# IEEE 1149.4 Mixed-Signal Test Bus Working Group Meeting Minutes

for  
November 14<sup>th</sup>, 2006

## 3. Review ABSDL Standard draft

**Figure 1** Differential receiver

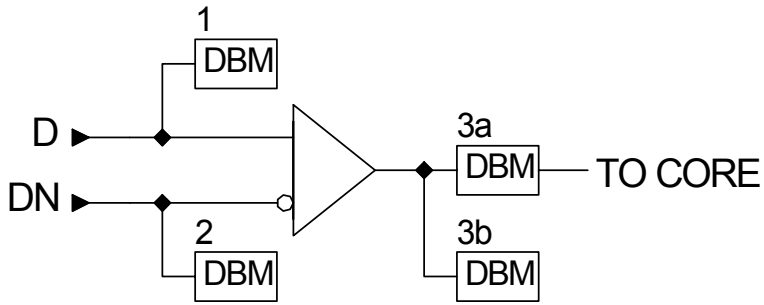
The discussion was based on the diagram shown in Figure 1 in the Appendix.

- Pin D (representative port) and pin DN (associated port) need to be defined in the grouped port identification.
- The functions for cell 1 and cell 2 that are attached to pins D and DN should be OBSERVE\_ONLY.
- If INTEST is supported, the differential capture cell is cell 3a. The cell function should be INPUT and its reference port is the representative port, where in this example is pin D. The cell can perform both control and observe operations.
- If INTEST is not supported, the differential capture cell is cell 3b. The cell function should be INTERNAL and the cell will be used to observe only. However the cell needs to be defined in MST differential statement. The differential digital record for attribute MST differential statement is shown in ABSDL draft, page 17, line 7;

If control and observe DBM cells are attached at D and DN in Figure 1 in the Appendix, those pins will not be defined in both grouped port identification and MST differential statement.

**Figure 2** Differential driver

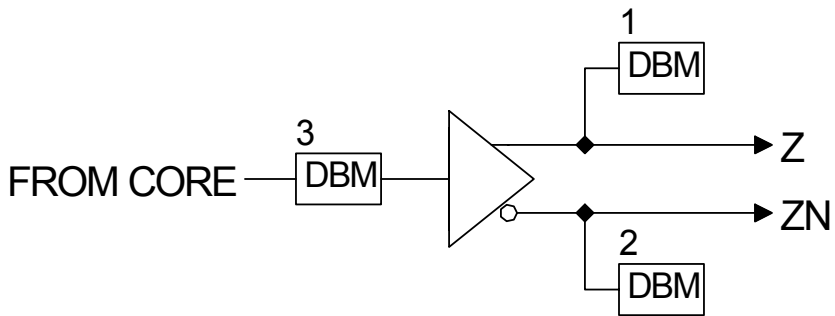
An example of differential driver is shown in Figure 2 in the Appendix. The description approach for differential receiver can be applied to differential driver.

- Pin Z (representative port) and pin ZN (associated port) need to be defined in the grouped port identification.
- The functions for cell 1 and cell 2 that are attached to pins Z and ZN should be OBSERVE\_ONLY.
- The function of input cell (cell 3) of the differential driver should be OUTPUT2 and its reference port is the representative port, where in this example is pin Z. The cell can perform both control and observe operations.

**Figure 3** Differential bidirectional

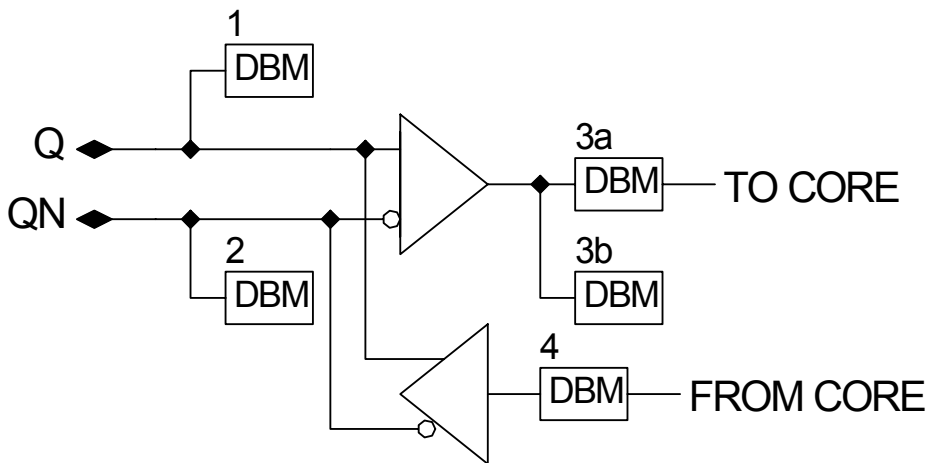
An example of differential bidirectional is shown in Figure 3 in the Appendix. Combination of description approaches for differential receiver and differential driver can be applied to differential bidirectional case.
